Civil Air Regulations Amendment 4b-6

AIRPLANE AIRWORTHINESS, TRANSPORT CATEGORIES

MISCELLANEOUS AMENDMENTS RESULTING FROM
THE 1956 ANNUAL AIRWORTHINESS REVIEW

Civil Air Regulations Amendment 4b-10

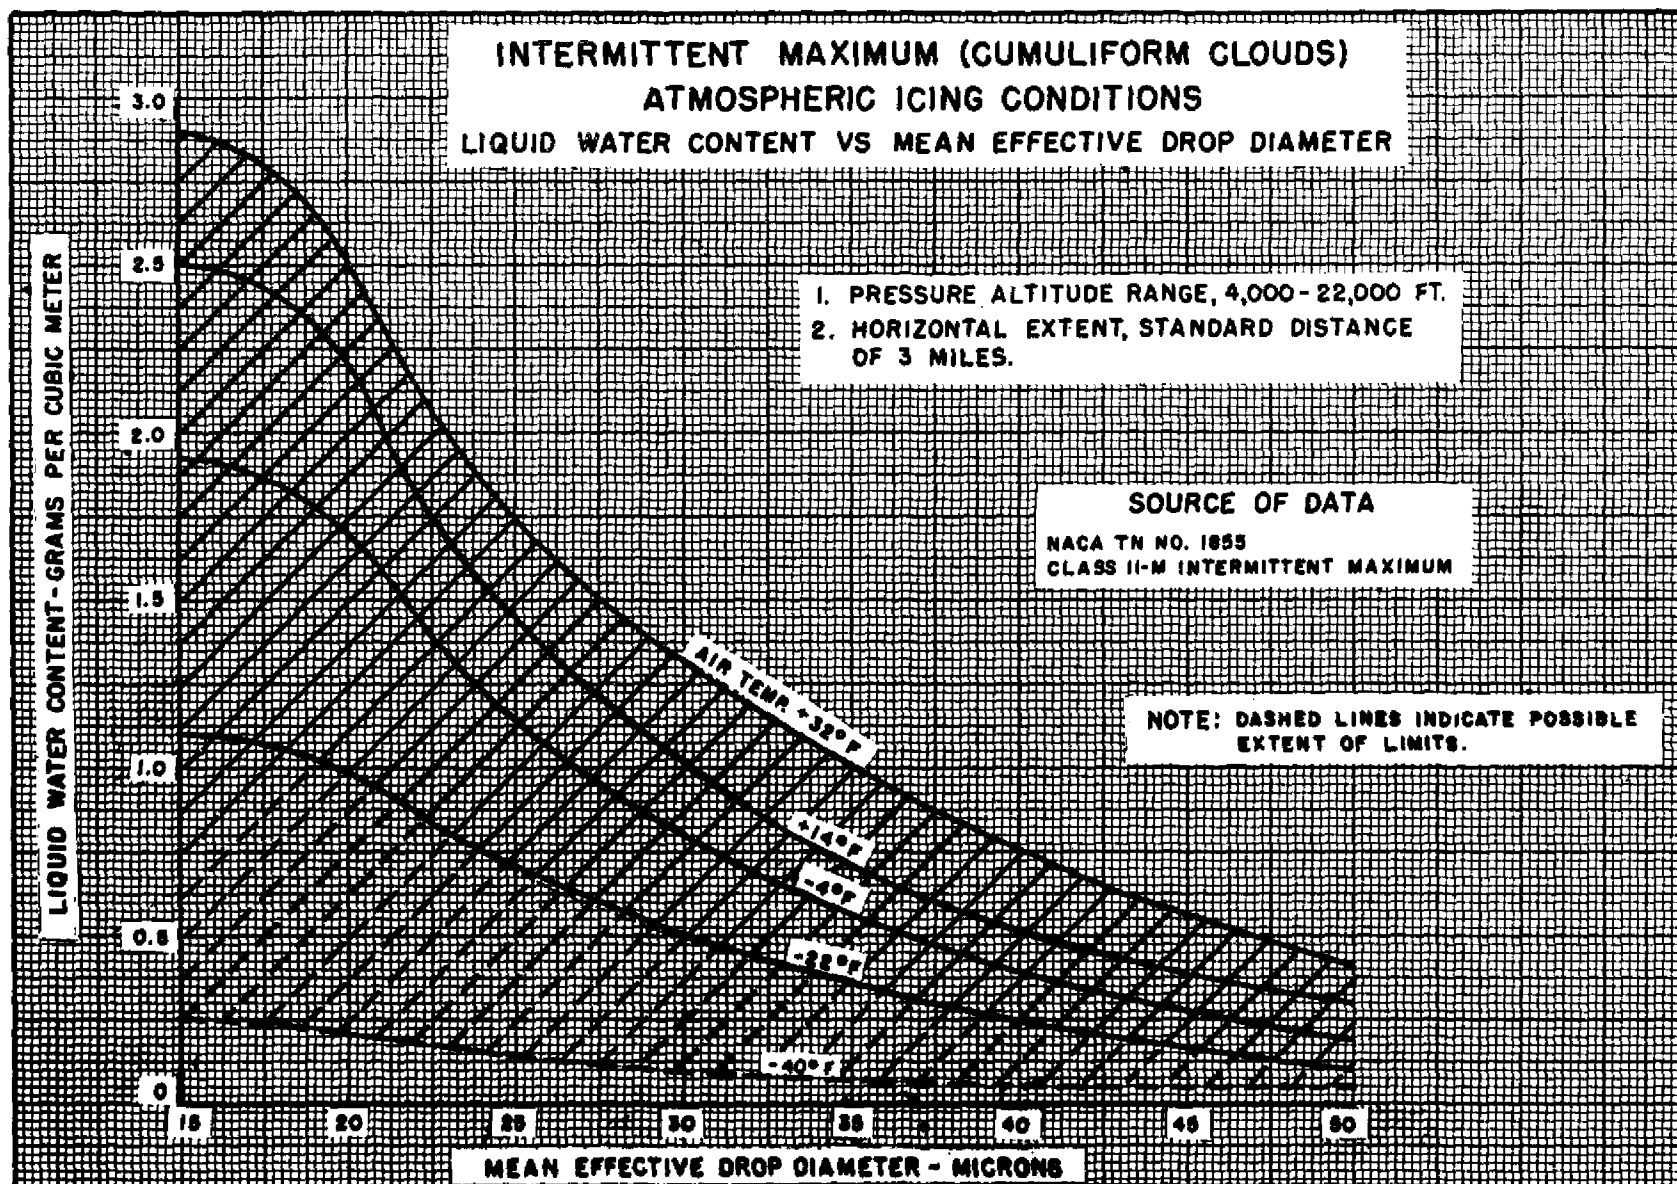
46. By amending Figures 4b-25a and 4b.25c.
